ZONING CHANGE REVIEW SHEETCASE: C14-2023-0063DISTRICT: 4ADDRESS: 6121 North IH-35ZONING FROM: CS-MU-NP and CS-1-NPTO: CH-PDA-NPSITE AREA: 7.91 acres (approximately 344,559 sq. ft.)PROPERTY OWNER: ASAP Austin, LLCAGENT: Drenner Group (David Anderson)CASE MANAGER: (512) 974-1057, jonathan.tomko@austintexas.govSTAFF RECOMMEDATION:

From: Nathan Aubert, P.E.
To: Santiago Araque, P.E., PTOE
Date: July 21, 2023
Subject: 6121 IH-35 – Zoning Transportation Analysis (C14-2023-0063)

Figure 1. Site Location

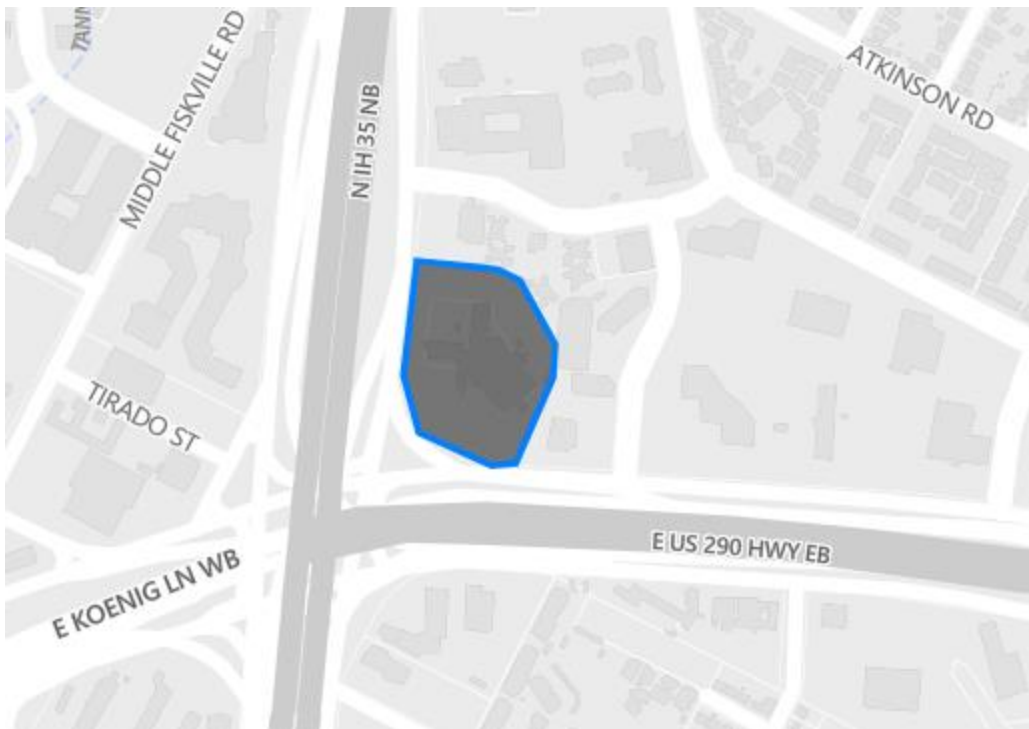
The Transportation Development Services (TDS) Division has reviewed the April 28, 2023 “6121 IH-35 Zoning Transportation Analysis”, prepared by Kimley-Horn. The proposal is for 1,000 (max) high-rise multifamily dwelling units, 40,000 square feet of retail, and 298 hotel rooms. The site is located on the northeast corner of IH-35 NB Frontage Road (NBFR) and US 290 Westbound Frontage Road (WBFR) as depicted on Figure 1 below.

Site access will consist of three right-in, right-out driveways: two along IH-35 NBFR, and one on US 290 WBFR. The development is anticipated to be constructed in one phase to be completed in 2028.

1. Provide no more than two driveways proposed along US 290 WBFR and IH 35 NBFR, replacing the existing driveways. Both driveways will operate as right-in, right-out. Final approval will be given by TxDOT as the site is directly accessing TxDOT roadways.
